CERTIFICATE OF APPROPRIATENESS

Property: 521 Euclid Street, Lot 1, Tracts 11 and 12A, Block 22, Woodland Heights Subdivision. The property includes a historic 1,222 square foot one-story wood frame single-family residence and a detached garage situated on a 5,000 square foot (50' x 100') interior lot.

Proposal: Alteration – Construct a two-story 2,049 square foot addition to the rear and to the side of a one story 1,222 square foot contributing residence.

Recommendation: Denial – Does not meet criteria.

LINE OF SIGHT DRAWING

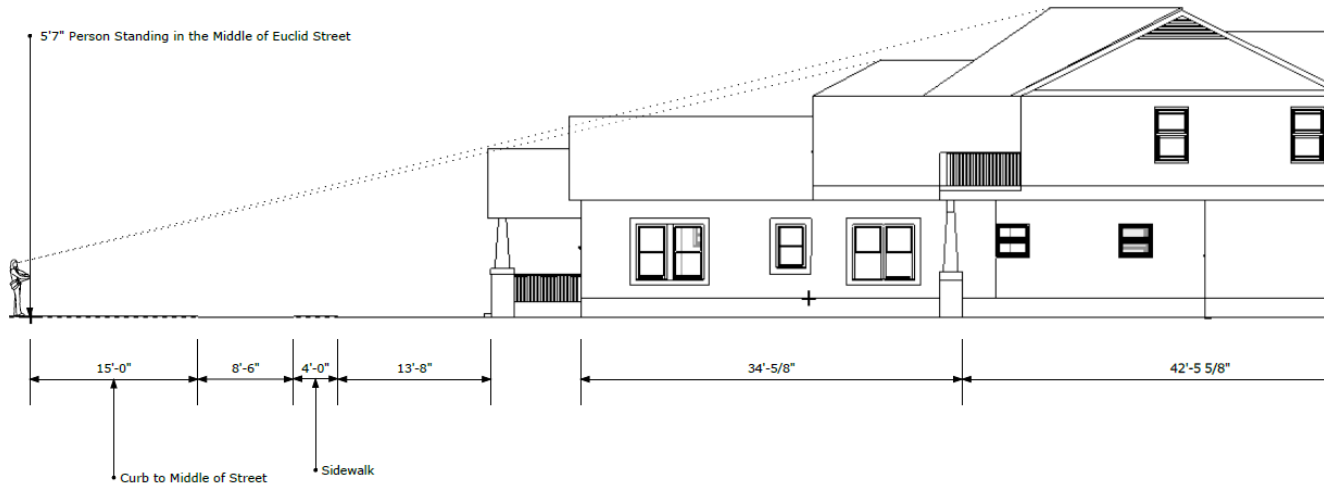
Although the simplification of visual elements and moving the addition behind the existing original house are appropriate changes, the increased height and placement of the upstairs living space closer to the street present additional compatibility issues with the scale of the addition.

SOUTH ELEVATION – FRONT FACING EUCLID STREET

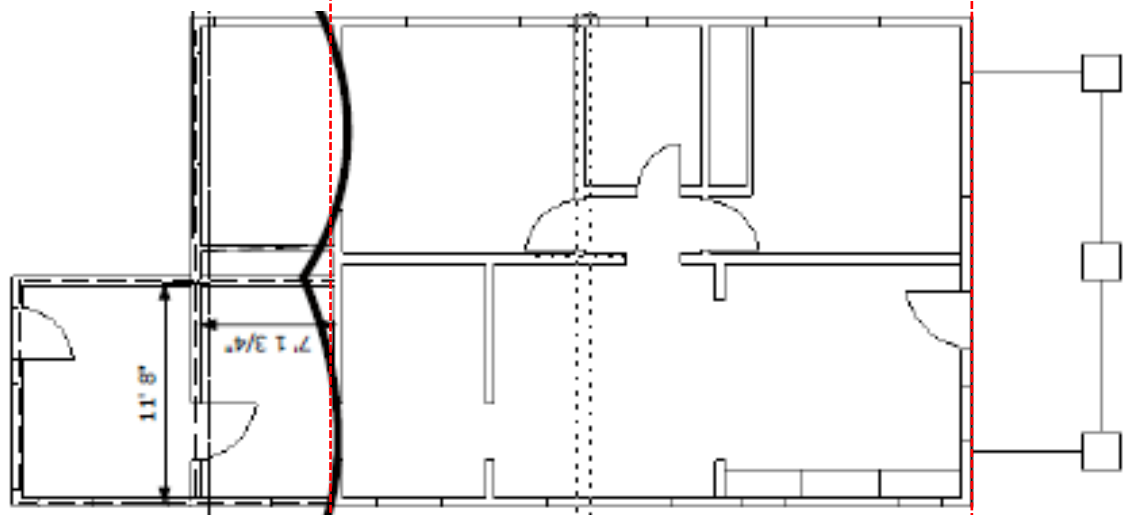
Side hipped and side gable roof changed to side gable

EAST SIDE ELEVATION

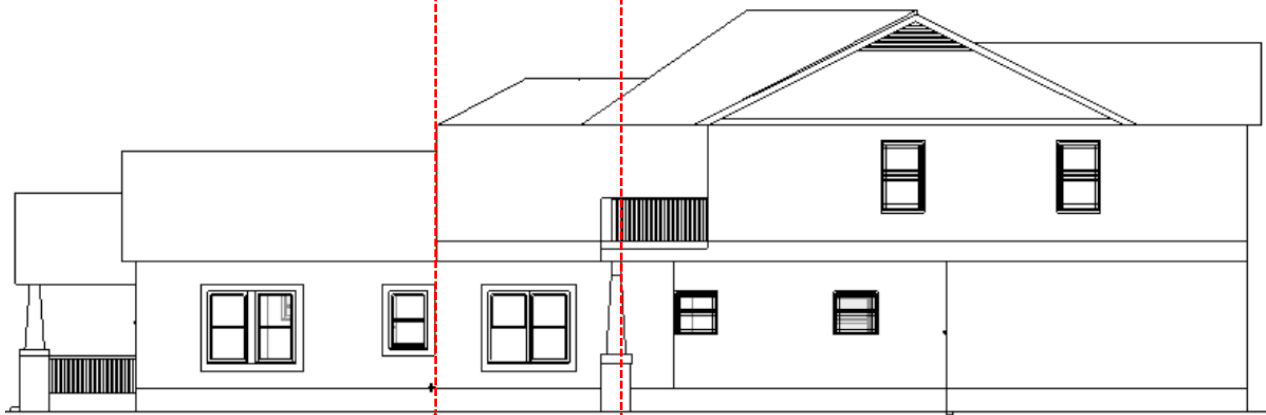
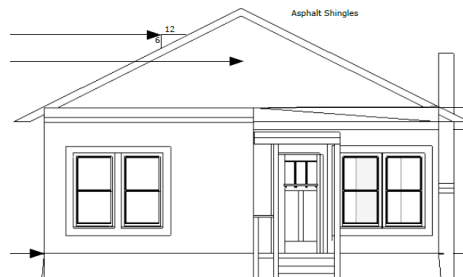
Revised: Hipped roof changed to side gable

Revised: addition no longer encroaches on the existing structure
